ARCHITECT'S SUPPLEMENTAL INSTRUCTIONS

PROJECT:	The Reserves at South Lake New Apartment Complex Grinnell, IA	Report No.	Three (3)
OWNER:	OPG South Lake Partners, LLC Dan Maximuk 234 N. Santa Fe Ave, Suite A Salina, KS 67401	Date	January 18, 2022
CONTRACTOR:	MCP Group 3501 SW Fairlawn Rd. Topeka, KS 66614	Architect's Proj No.	20-3118
		Contract For:	General Construction Mechanical, Electrical

IFA Plan Review

C ACCESSIBLE 1 BEDROOM FLOOR PLAN

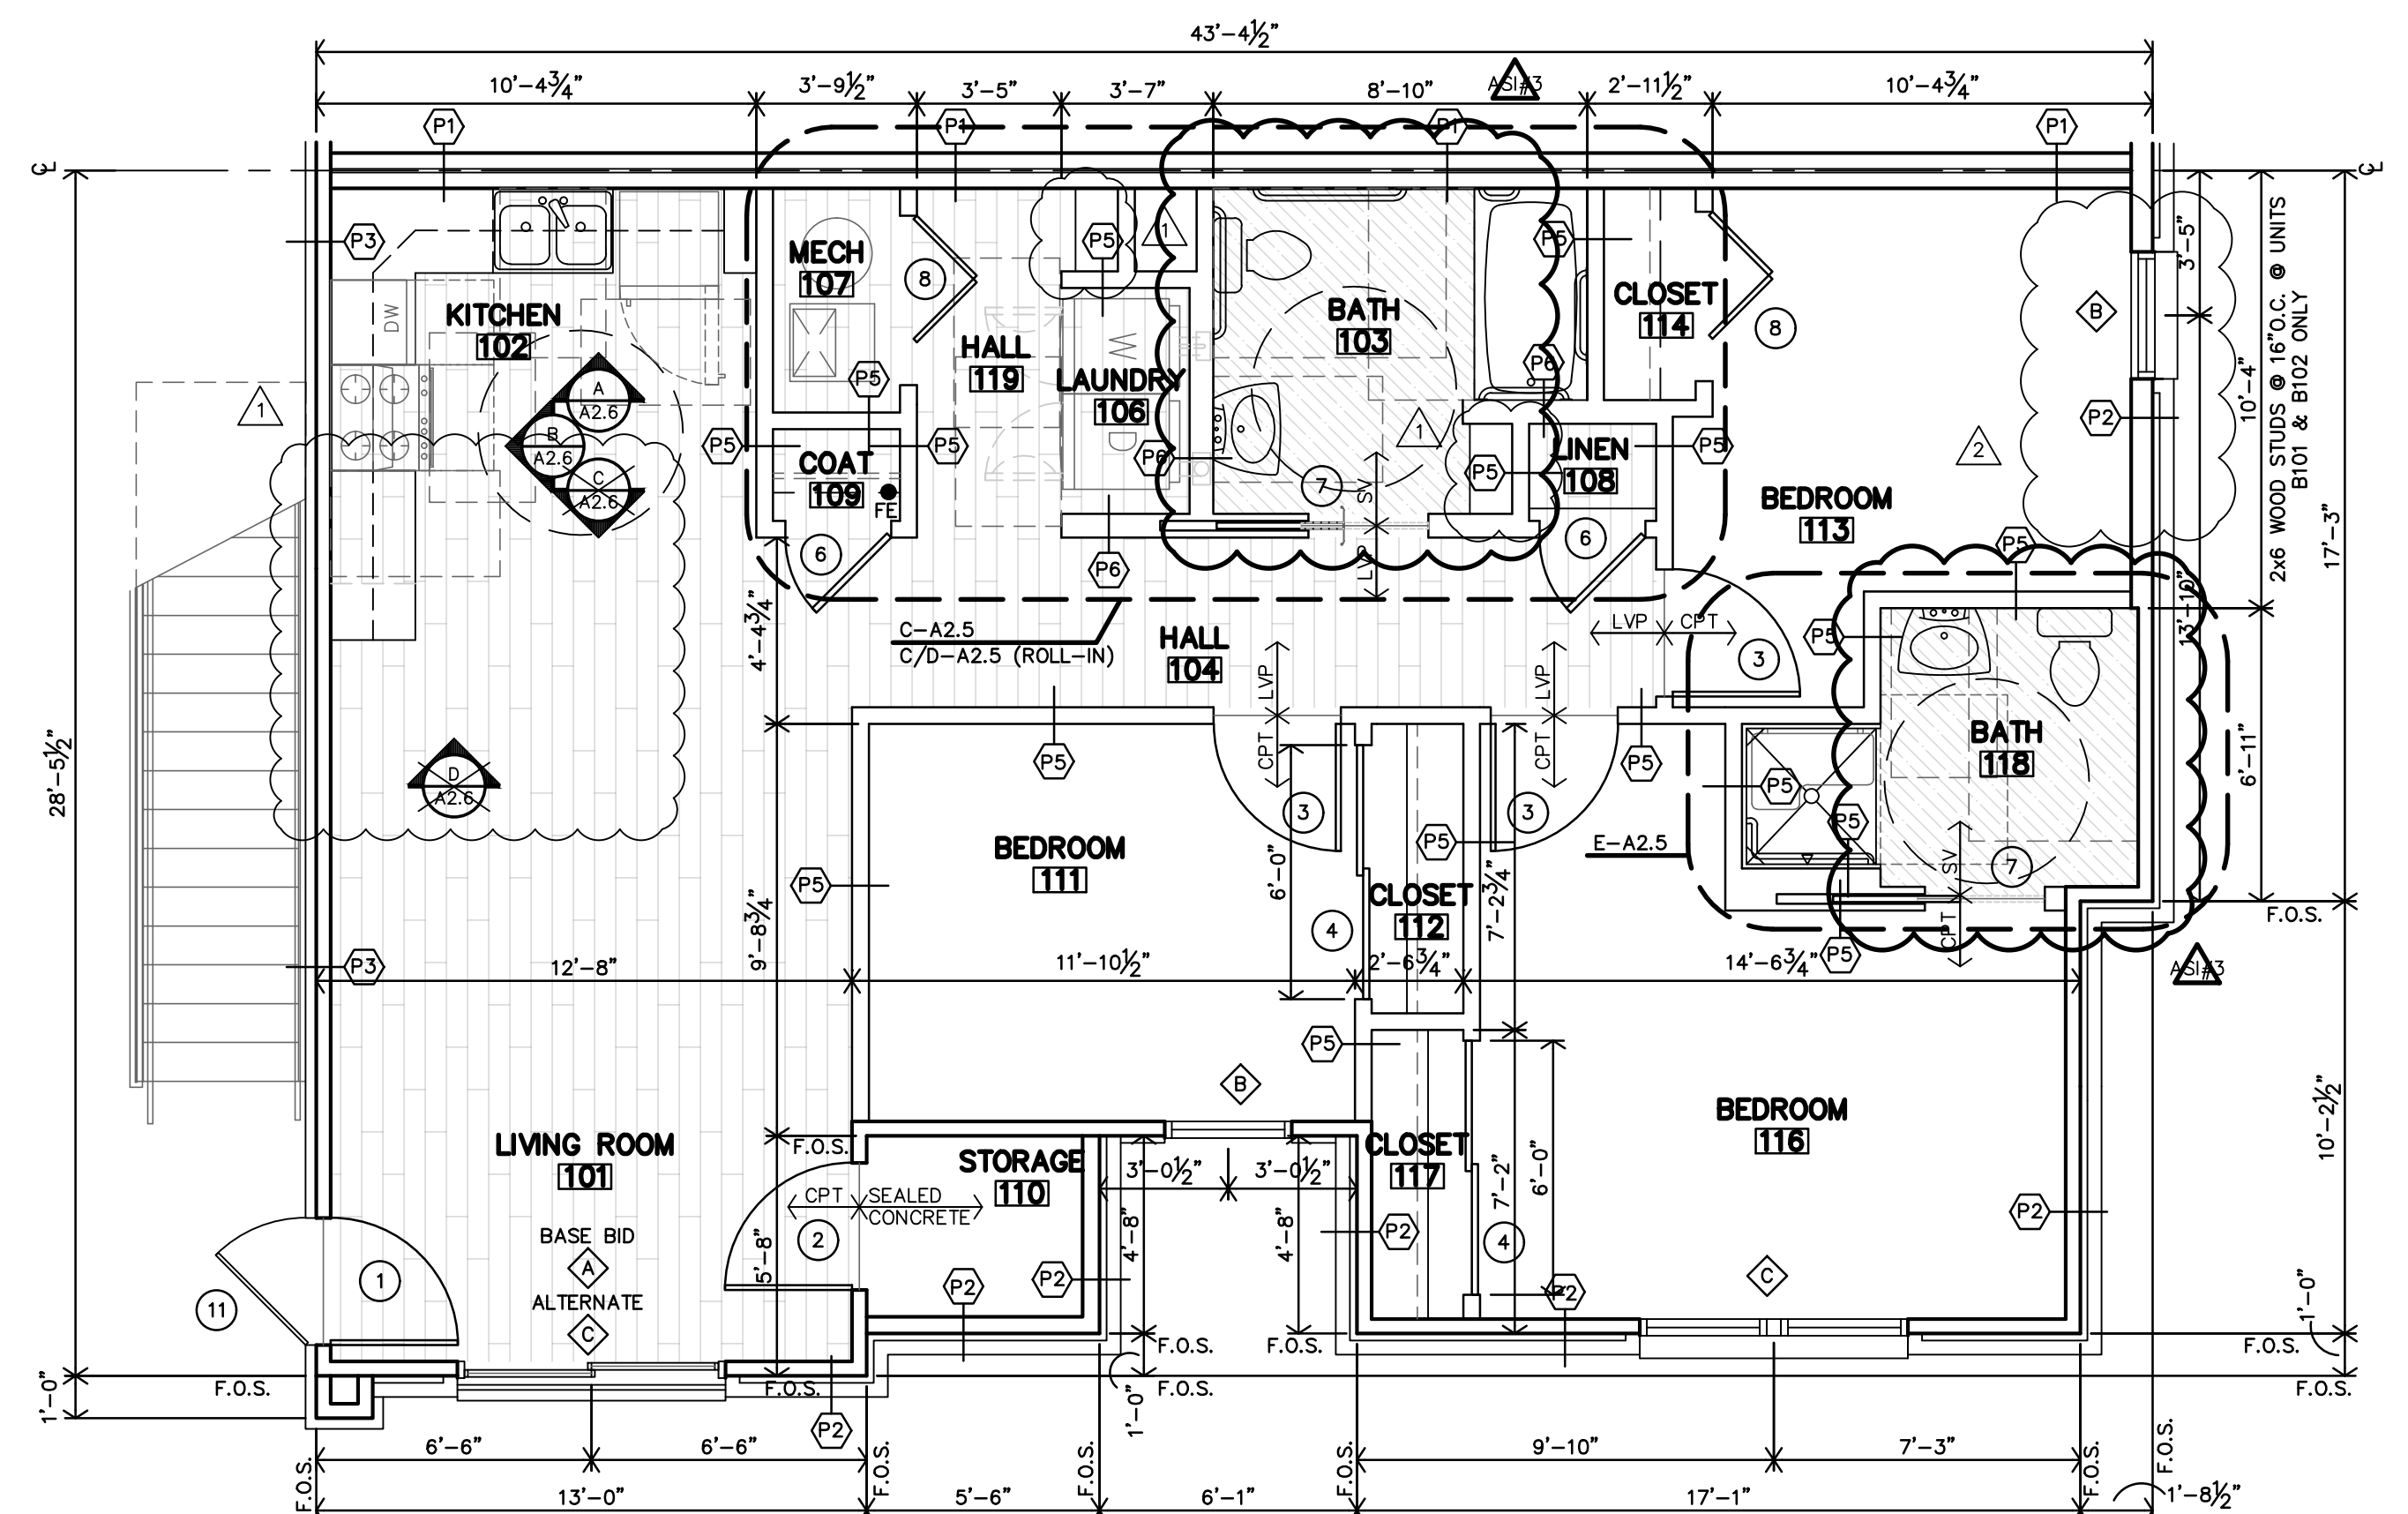
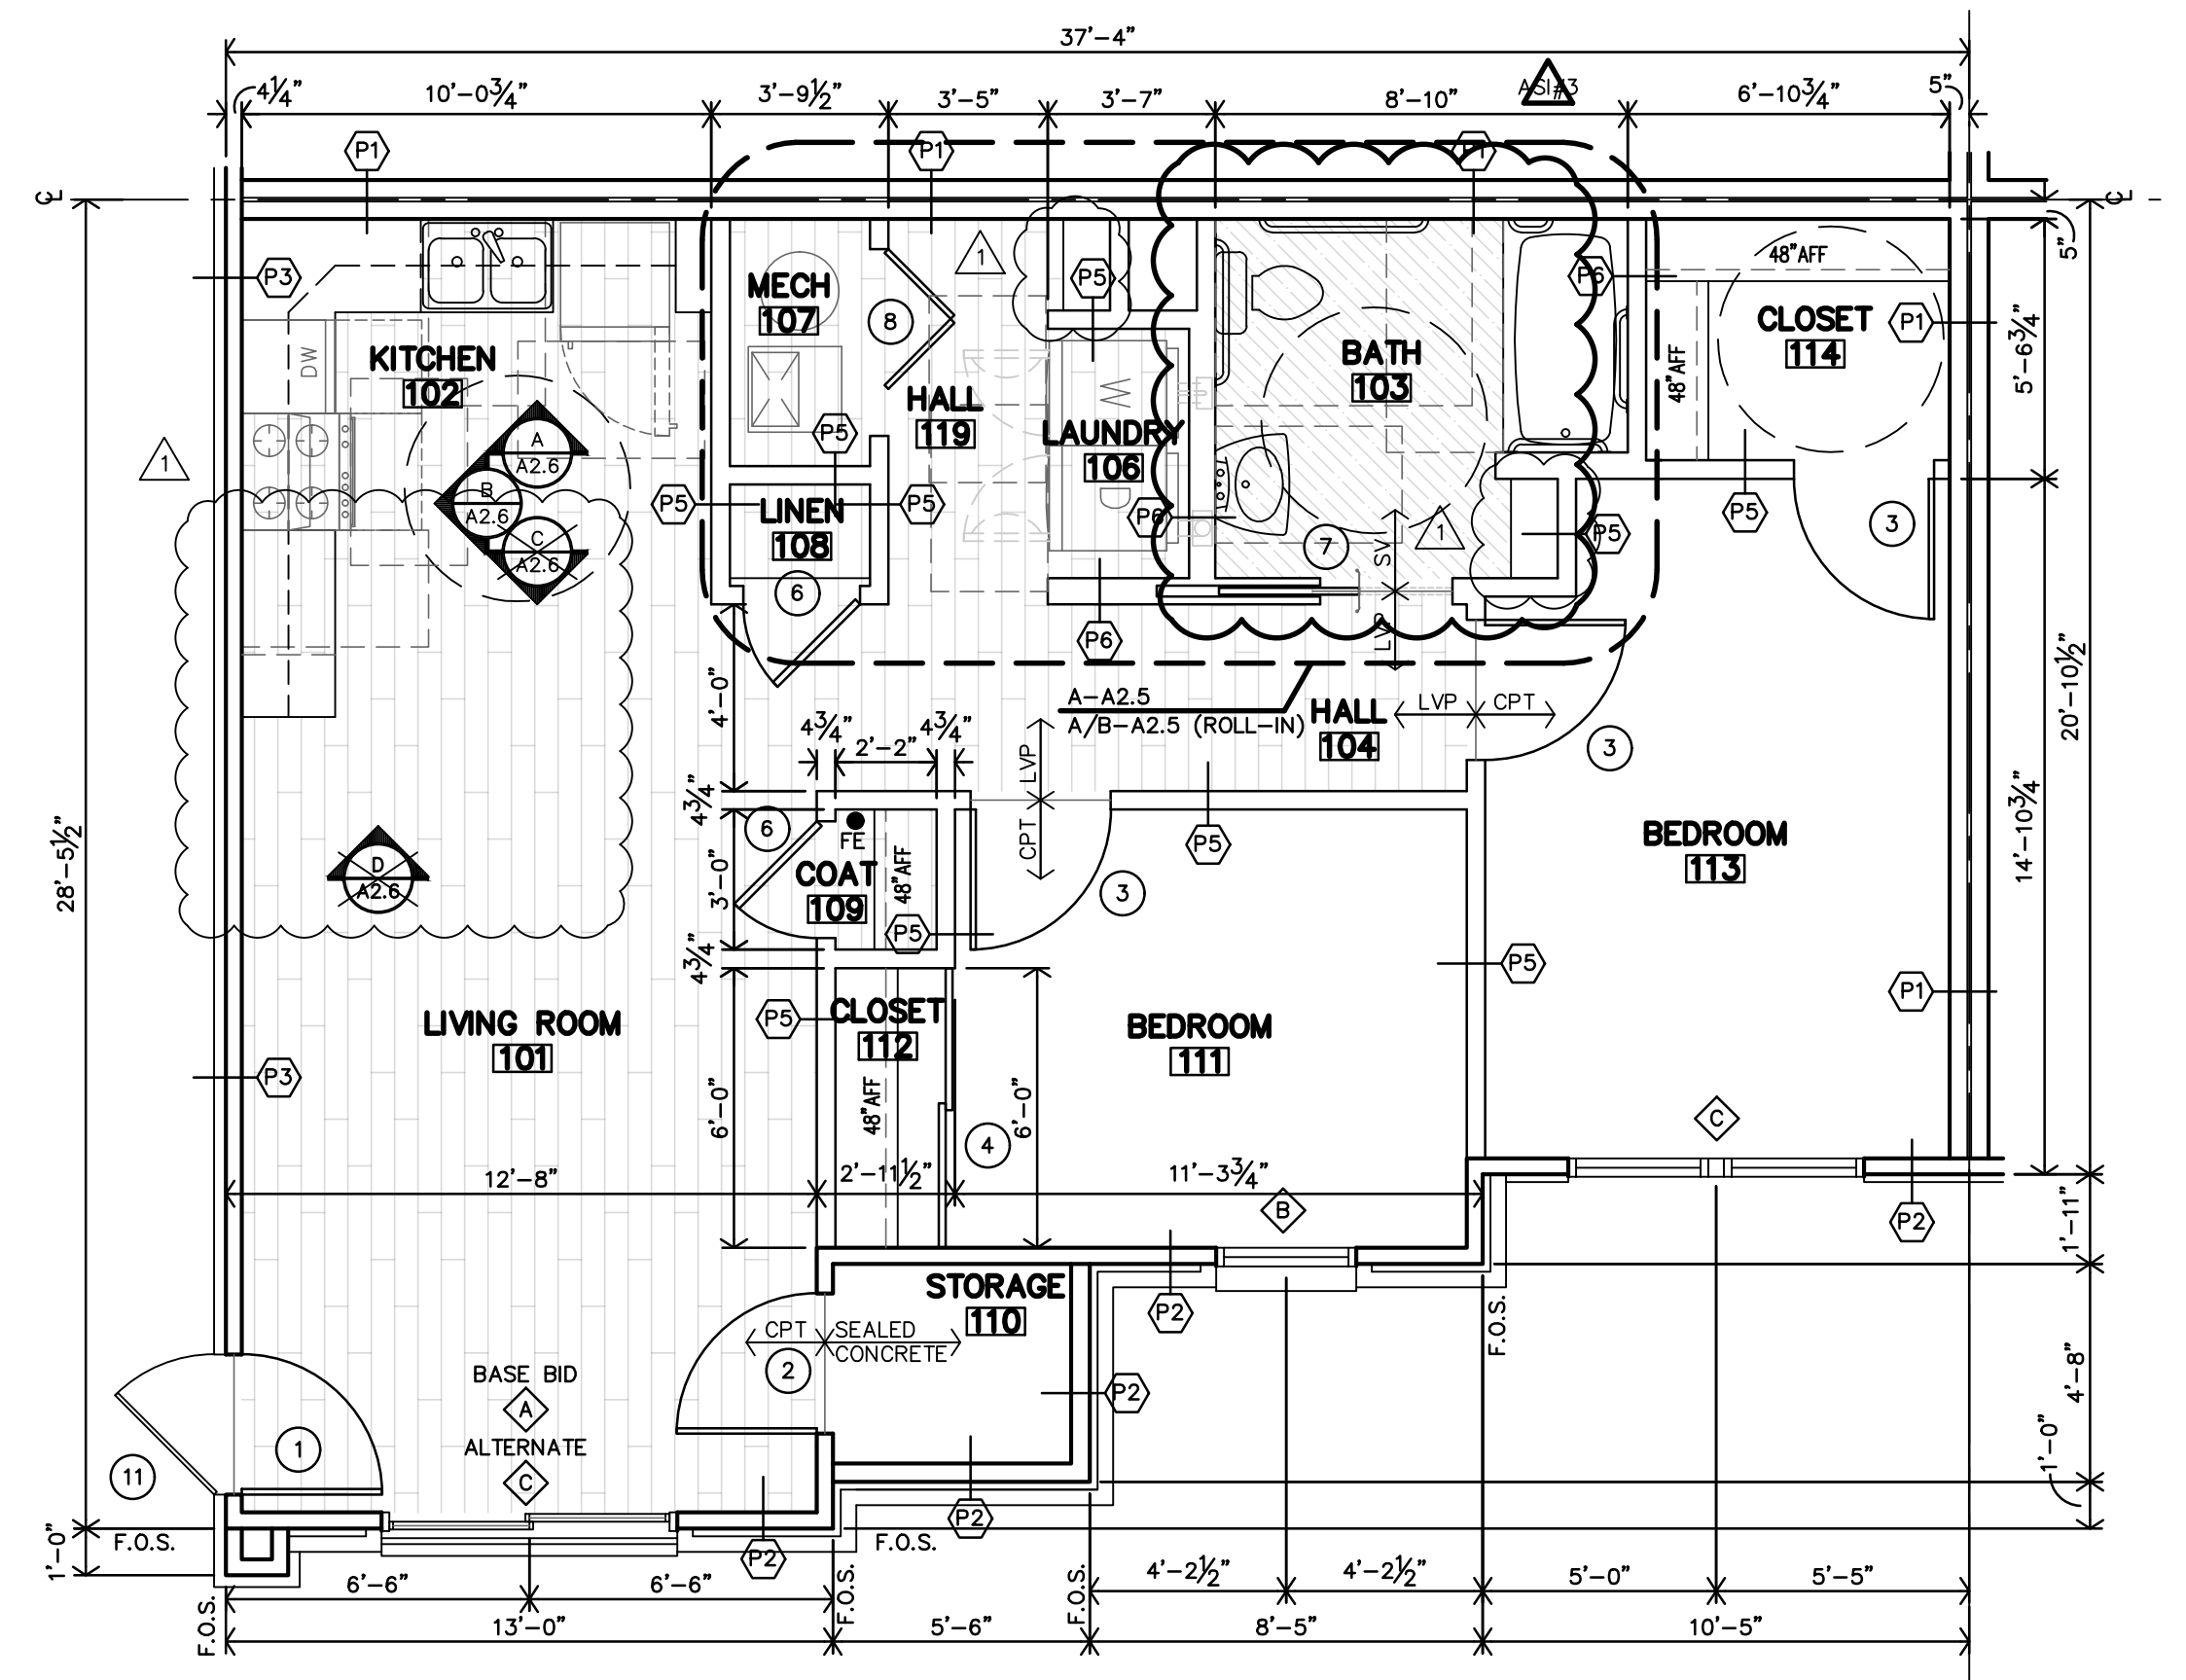
2. Apartment Door Schedule: Door 1 has been changed to a steel frame.
 - iii. Sheet A2.4 – Floor Plans A, B & C – Finished flooring material in Baths have been changed to Sheet Vinyl.

8. Bathroom floors must be a sheet vinyl product that meets QAP requirements. See G.6.3 in Part C – Threshold Requirements... Sheets A2.1, A2.2 and A2.4 have been revised to show bathrooms floors as Sheet Vinyl product. Specifications have been revised as well. Attached.
